UNITED STATES PATENT AND TRADEMARK OFFICE
CERTIFICATE OF CORRECTION

PATENT NO. : 6,838,319 B1
APPLICATION NO. : 09/652503
DATED : January 4, 2005
INVENTOR(S) : Vernon M. Williams

FIG. 1
(PRIOR ART)

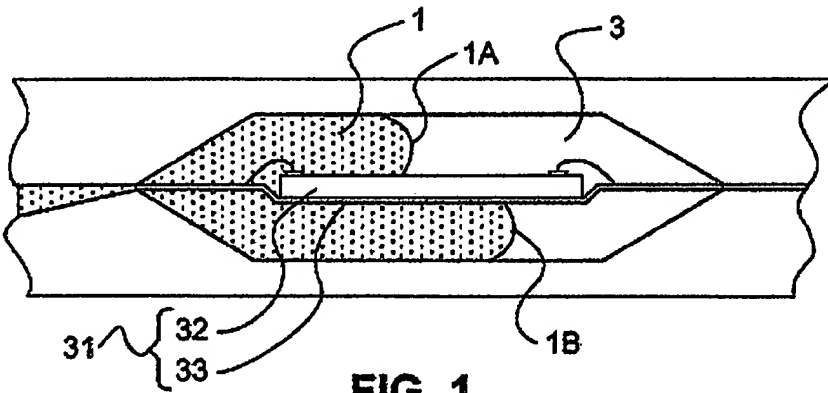
In FIG. 1,	directly underneath " FIG. 1 " insert --(PRIOR ART)--
In FIG. 2,	directly underneath " FIG. 2 " insert --(PRIOR ART)--
In FIG. 3,	directly underneath " FIG. 3 " insert --(PRIOR ART)--
